PLANNING COMMISSION STAFF REPORT

**Harmons Emigration Market
Planned Development
Petition No. PLNPCM2010-00672
1706 E 1300 South
December 8, 2010**

Planning and Zoning Division
Department of Community and
Economic Development

WEST ELEVATION

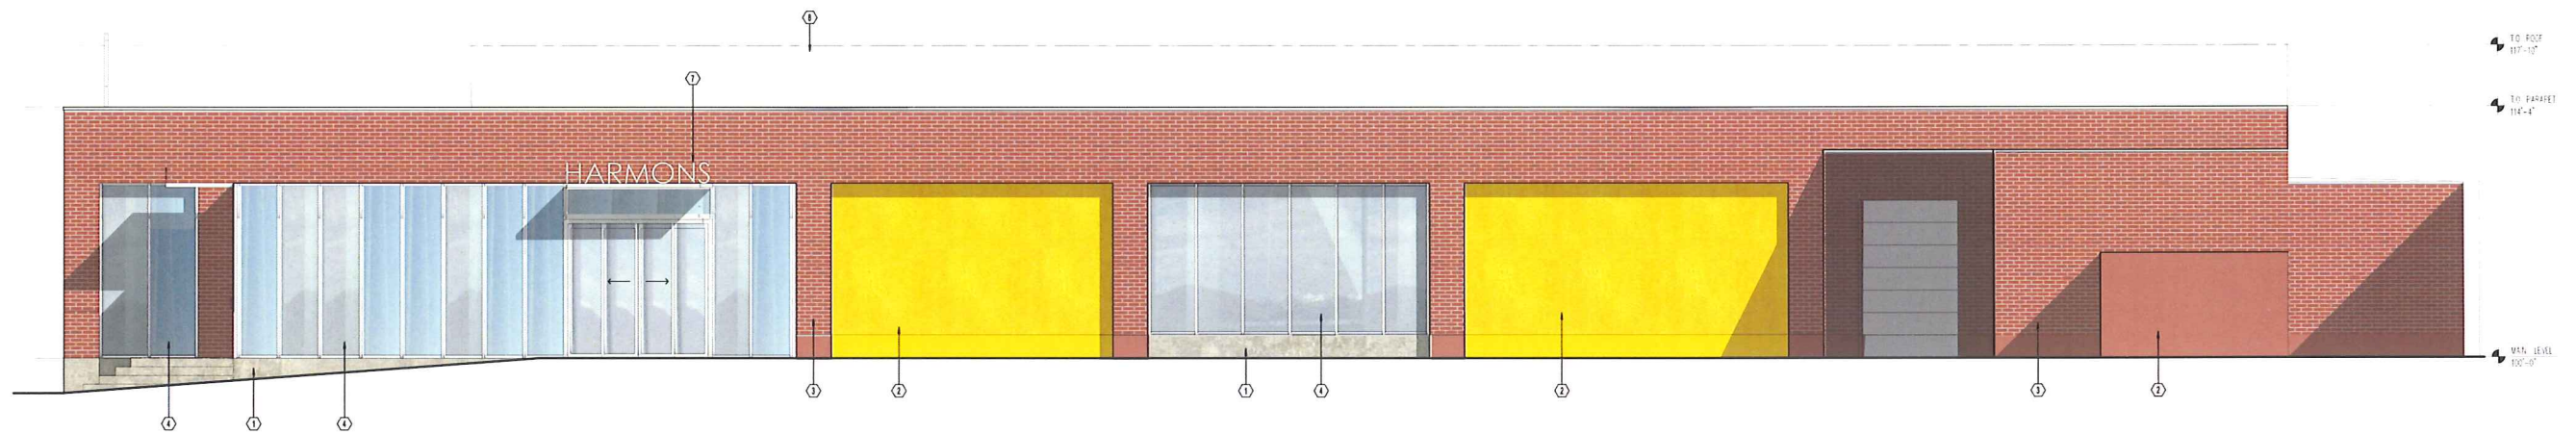
There are concerns that replacing the glass windows with glazed panels along 1700 East would reduce the pedestrian orientation of the building. The new “Harmons” roof signs do not comply with current zoning regulations. The application needs to be amended to include this signage.

Harmons proposes to replace the glass windows along 1700 East with panels that transition from translucent glazing to transparent glass roughly 4’ 6” above the sidewalk grade. Harmons makes this request because it plans to place the bakery/deli work area along 1700 East. Staff believes the transition from translucent panels to transparent glass should occur at a lower elevation to maintain the building’s pedestrian orientation.

Finding: Staff finds that Harmons generally meets this standard in its planned development application but believes the standard would be further met if Harmons was required to place transparent glass beginning at 3 feet above sidewalk elevation along 1700 East to promote the building’s pedestrian orientation.

Harmons has revised its application to show a transition from translucent glass to clear glazing at 42” above finished floor grade. Staff feels that the windows should be transparent glass or the transition should be lower. Staff feels that this condition should be included as part of the approval. The “Harmons” signs above the entrance vestibules have been included in the planned development application.
